Re: *North American Electric Reliability Corporation*

The North American Electric Reliability Corporation (“NERC”) hereby submits this petition for approval of one proposed Regional Reliability Standard of the Western Electricity Coordinating Council (“WECC”), BAL-002-WECC-1 — Contingency Reserves, contained in **Exhibit A** to this petition. Upon the effective date of BAL-002-WECC-1, NERC requests the retirement of BAL-STD-002-0. The proposed Regional Reliability Standard was approved by the NERC Board of Trustees at its October 29, 2008 meeting. NERC requests an effective date of 90 calendar days after receipt of approval.¹

**PETITION OF THE
NORTH AMERICAN ELECTRIC RELIABILITY CORPORATION
FOR APPROVAL OF PROPOSED WESTERN ELECTRICITY
COORDINATING COUNCIL REGIONAL RELIABILITY STANDARD
REGARDING CONTINGENCY RESERVES**

Attachment 2

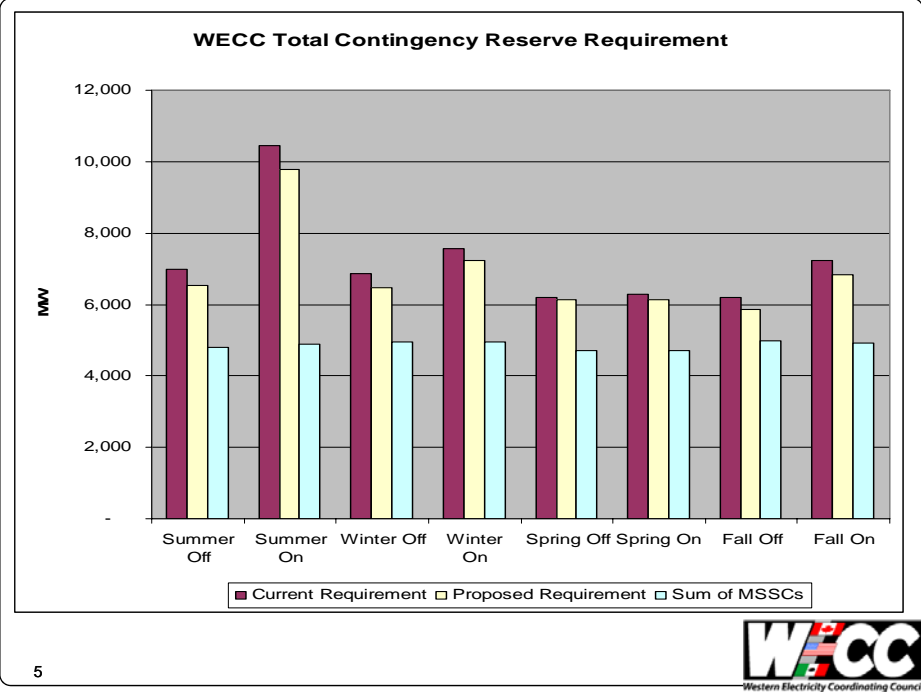
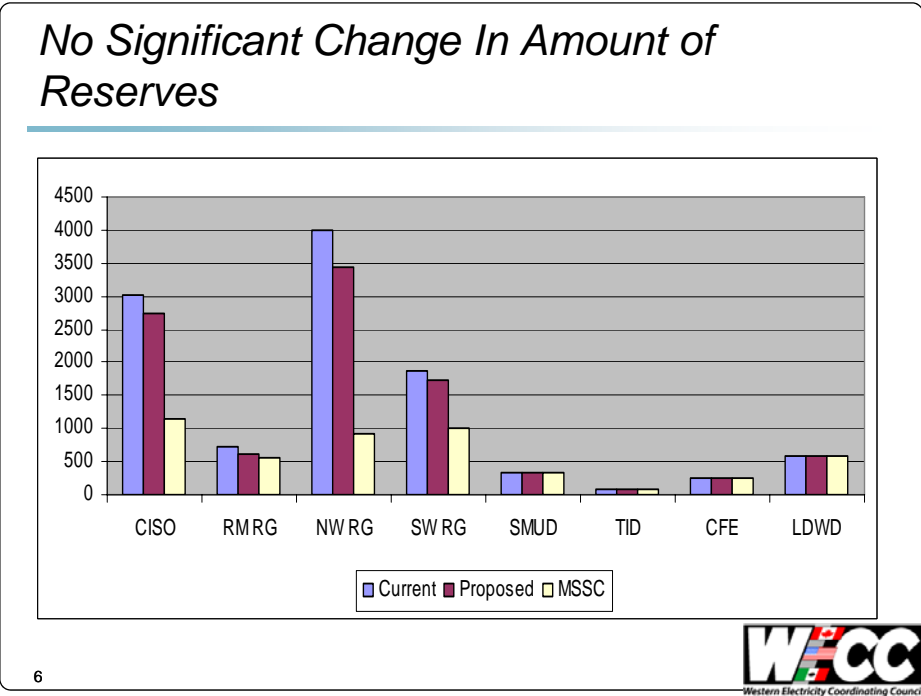
- It clearly identifies the responsible entity and creates a measurable requirement by imposing a Contingency Reserve Requirement based upon a BA's generation (3%) and load (3%).
- It maintains WECC Contingency Reserves similar to today's levels (if not higher, since it is currently unknown whether reserves are being held for some transactions). Based on information provided to the drafting team, the proposed requirements would cause an overall decrease of WECC required reserves of approximately 350 MWs (from approximately 10,850 MWs to 10,500 MWs) on high load days. The largest change of required contingency reserves during the hours reviewed indicate a decrease of 650 MW.
